**Government of India  
Ministry of Railways  
Research, Designs & Standards Organisation  
Manak Nagar, Lucknow - 226 011**

No. EL/3.2.30/CG

**MODIFICATION SHEET NO. RDSO/WAM4/146**

**Provision of grub screws for locking bush and gear housing  
assembly of Manual Drive for Tap Changer No.32 HBB make.**

SK.EL. 3835

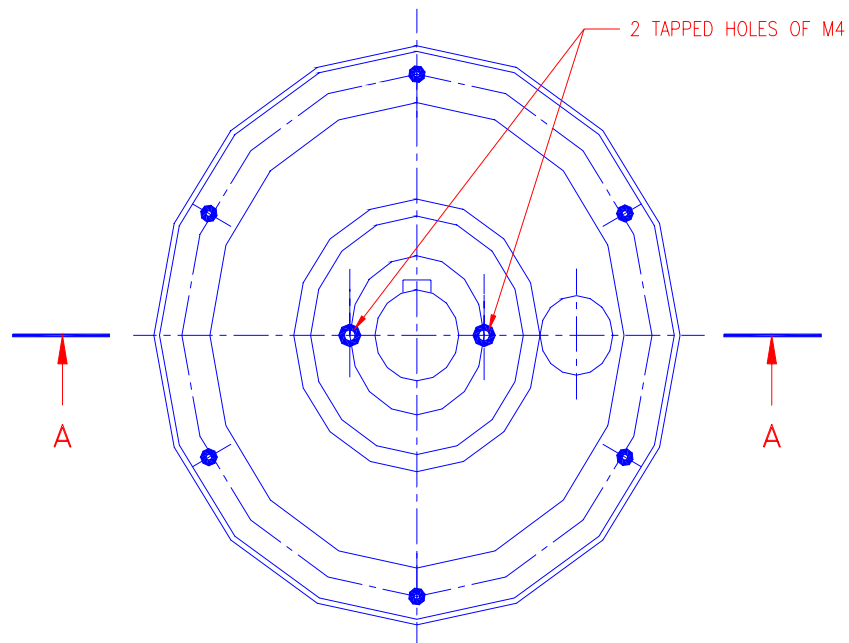
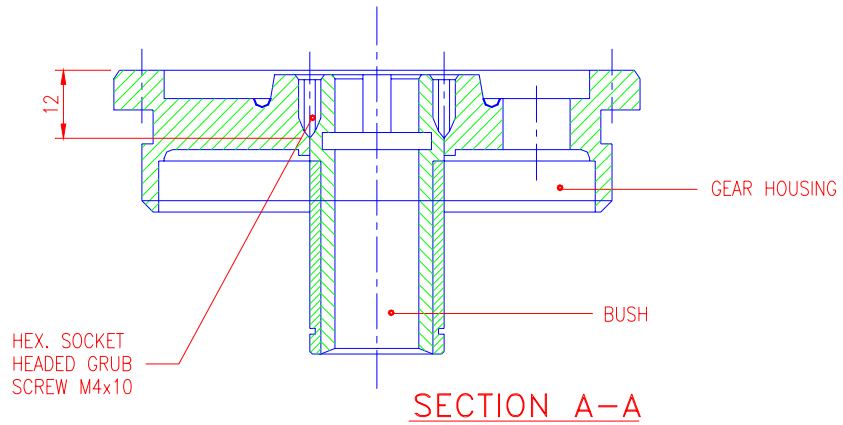
Railways have reported a few cases of slipping of notch indicator on the shaft and hence depicting wrong notch. Investigations have shown that BBC had provided only loctite instead of providing loctite at the interface of bush and gear housing as well as the grub screws. BBC supplied 74 sets of Manual Drive from 1970 onwards without grub screws but with loctite to Indian Railways. It is decided to provide two grub screws as per the following instructions.

- Dismantle the manual drive assembly.
- Check that the grub screws are provided, if not.
- Drill and tap two numbers of M4 threaded holes diametrically opposite to each other with their centre coinciding with the joining dia of the two components as indicated in the enclosed SK EL 3835 (Ensure partial tapping in bush and partial tapping in gear housing).
- Insert hex socket headed grub screw M4 x 10 and ensure that it does not project out of the housing.
- Assemble the Manual Drive after normal overhauling.

Hex. socket headed grub screws (M4 x 10) - 2 Nos..
